## ADDENDUM No. 3

### RFP No. 22-76

#### East Medical Center Drive Bridge Rehabilitation and Widening Project

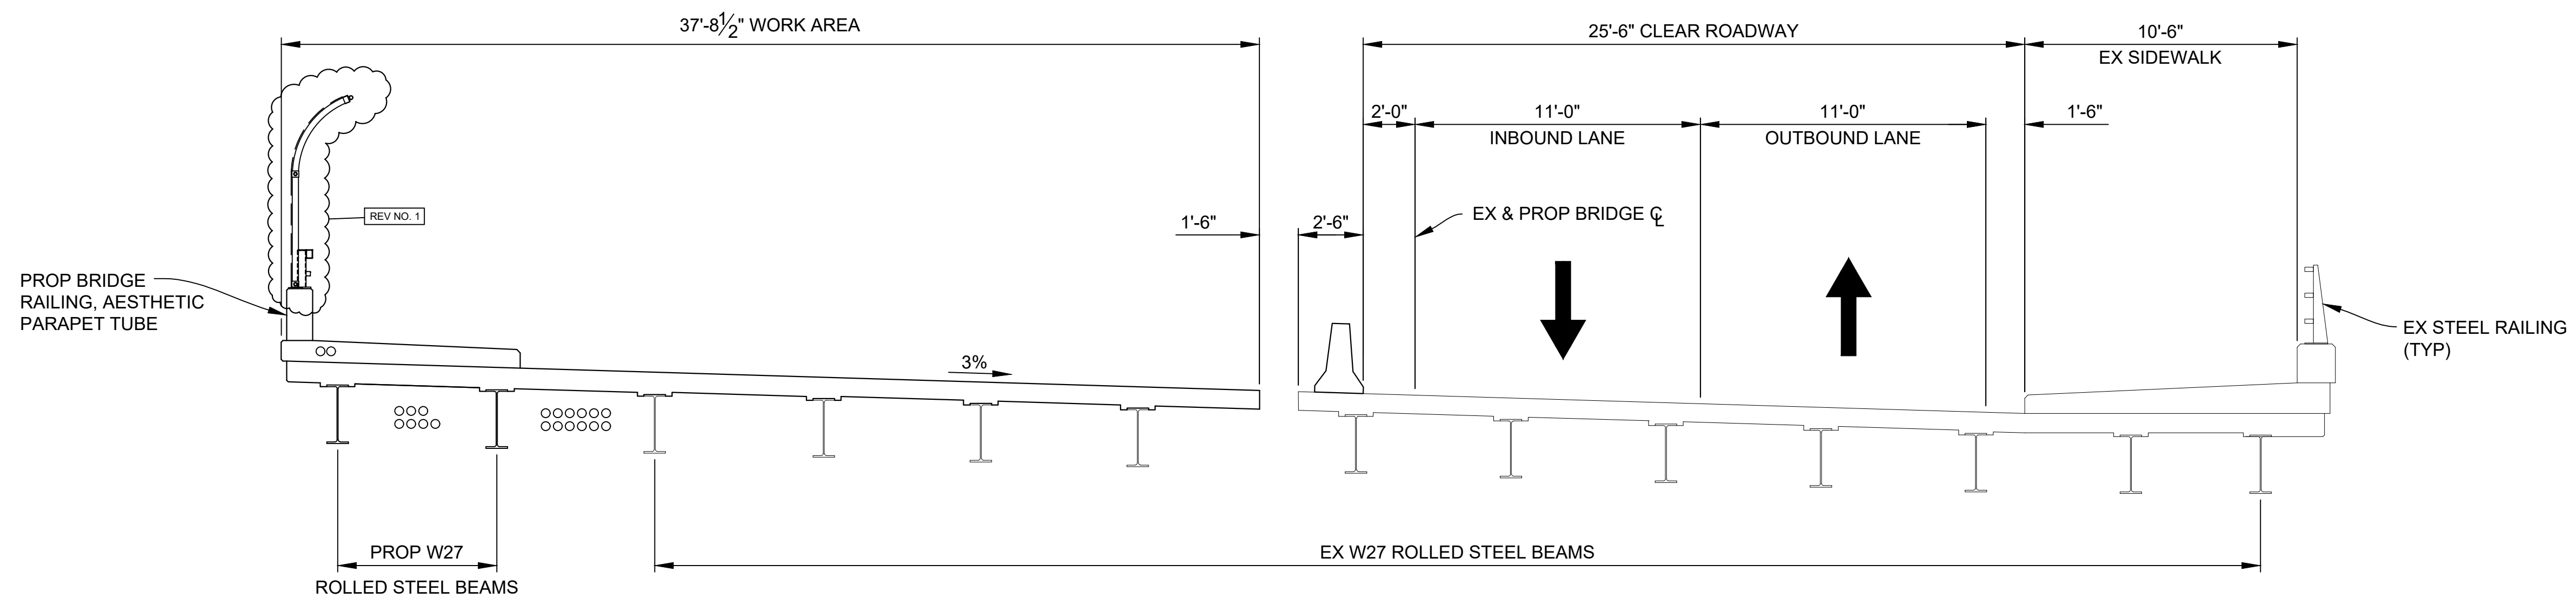
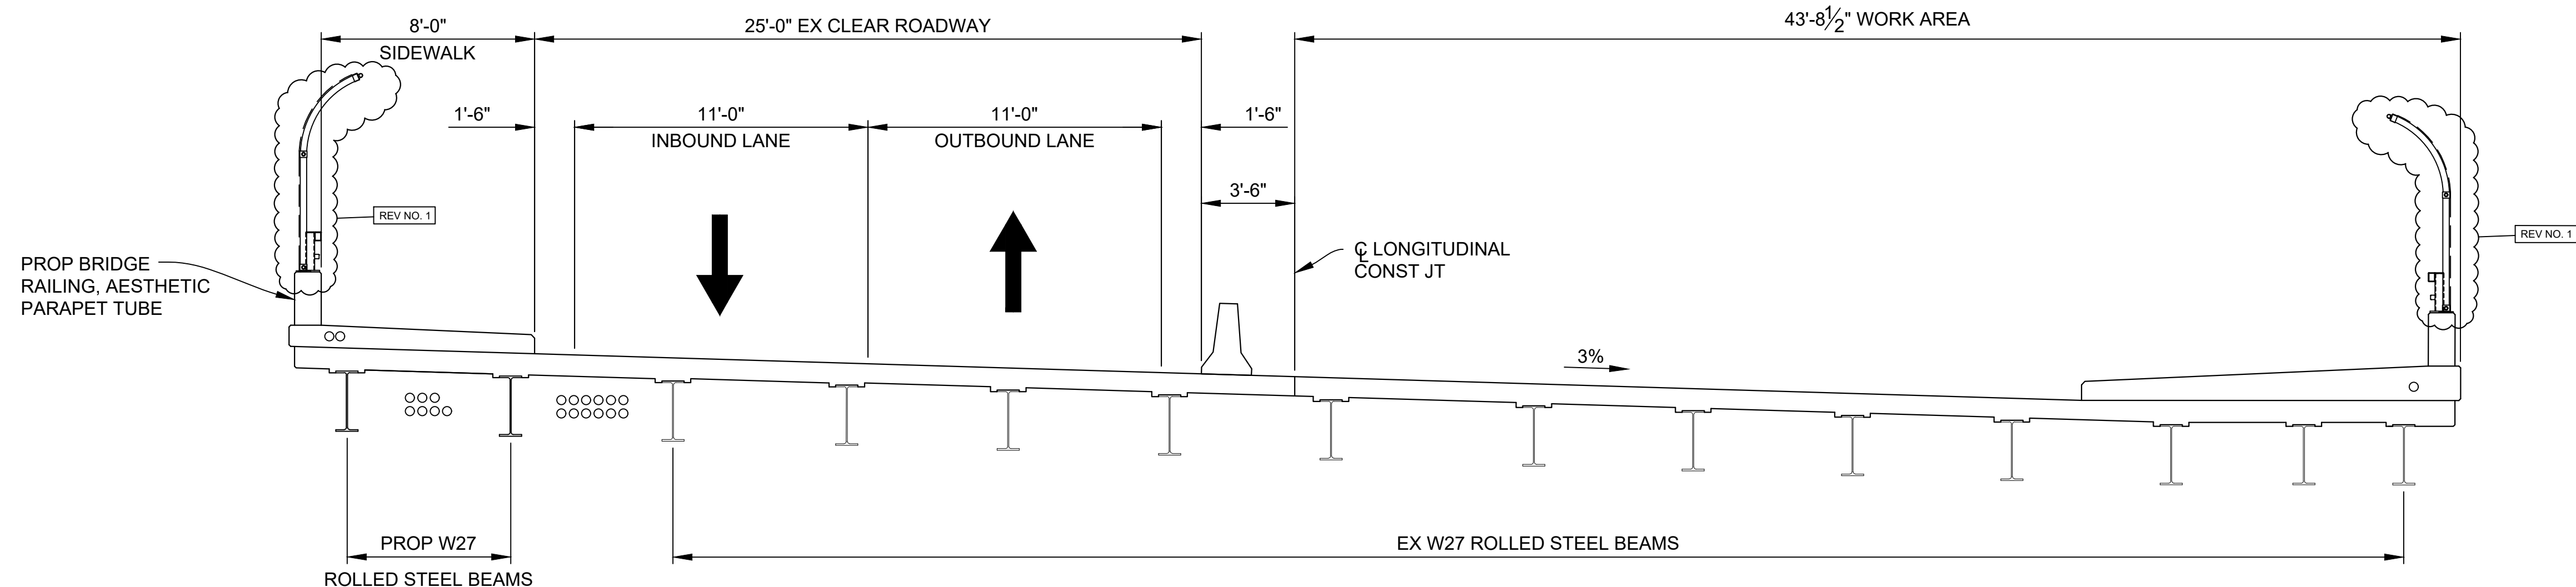
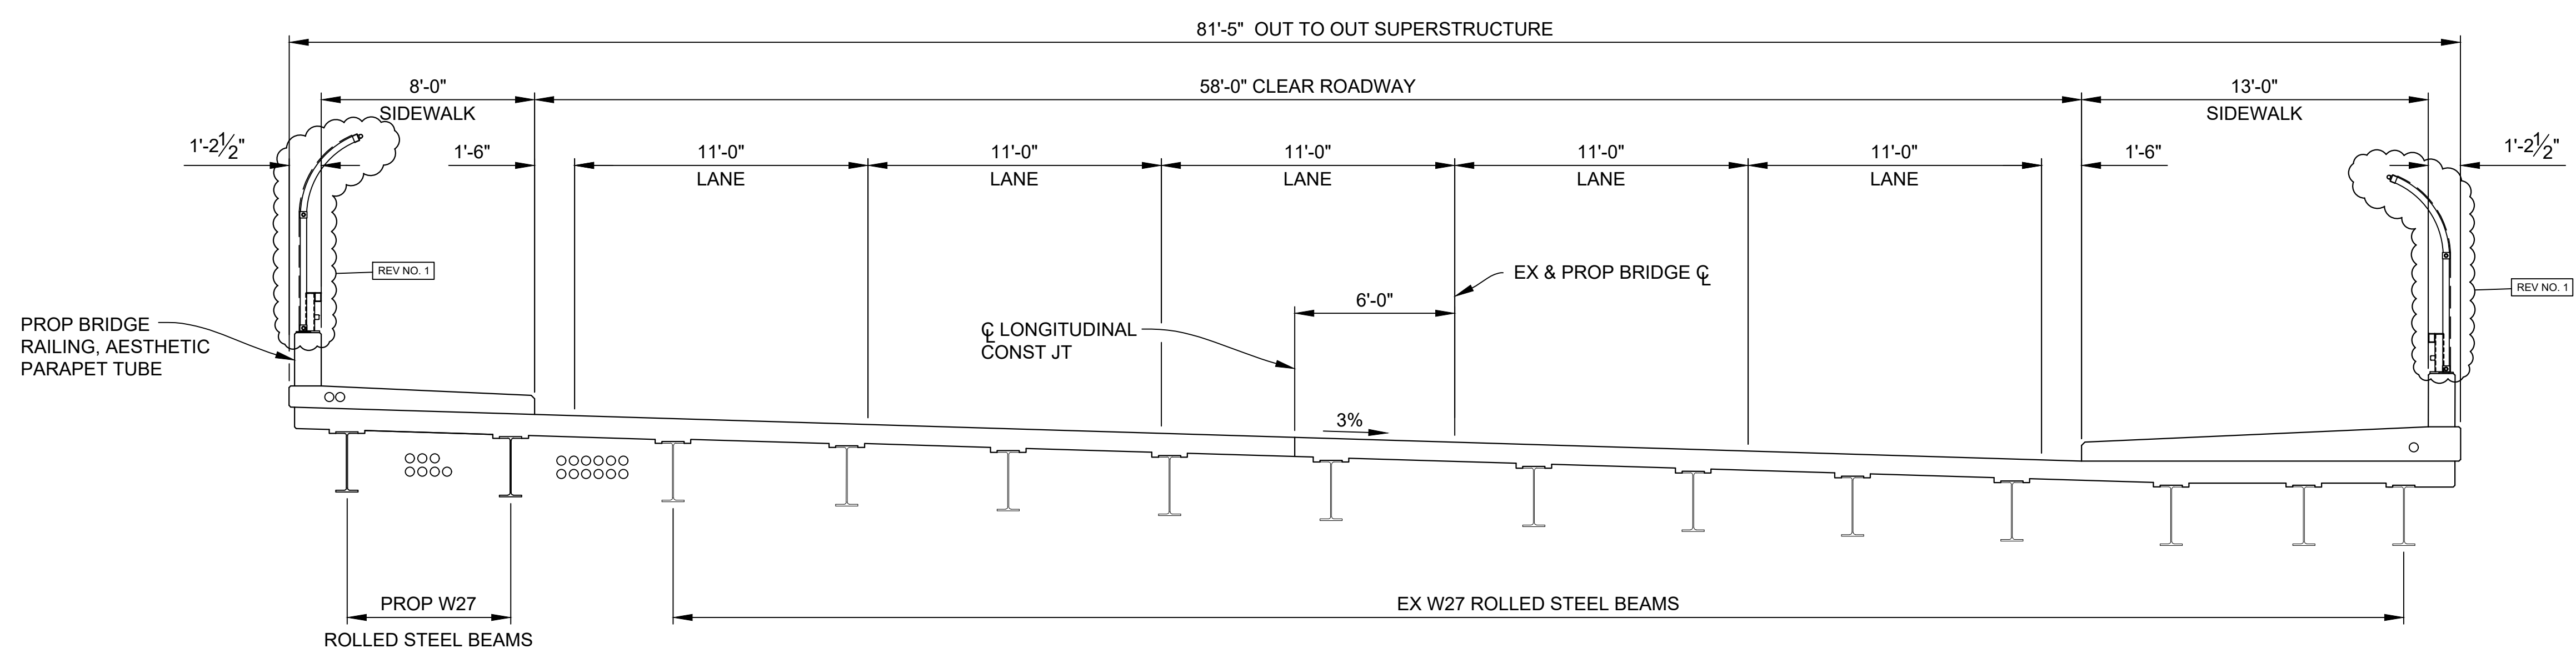
RFP_22-76_Plans Sheet 11	The cross-section was updated to show a proposed chain link fence on top of the barrier.
RFP_22-76_Plans Sheet 12	The cross-sections were updated to show a proposed chain link fence on top of the barrier.
RFP_22-76_Plans Sheet 69	The elevation view was updated to show a proposed chain link fence on top of the barrier.
RFP_22-76_Plans Sheet 70	The cross-section was updated to show a proposed chain link fence on top of the barrier.
RFP_22-76_Plans Sheet 91	<p>Additional bolted steel repairs were added based on the results of the October 2022 bridge inspection.</p> <p>The "Structural Steel, Mixed, Erect" and "Structural Steel, Mixed, Furn and Fab" CATG 0001 quantities have been increased from 32,419 lb to 38,695 lb and the total quantity was increased from 46,581 lb to 52,857 lb.</p> <p>The "Beam Plate, Seal Perimeter" quantity was increased from 1,660 ft to 2,320 ft.</p>
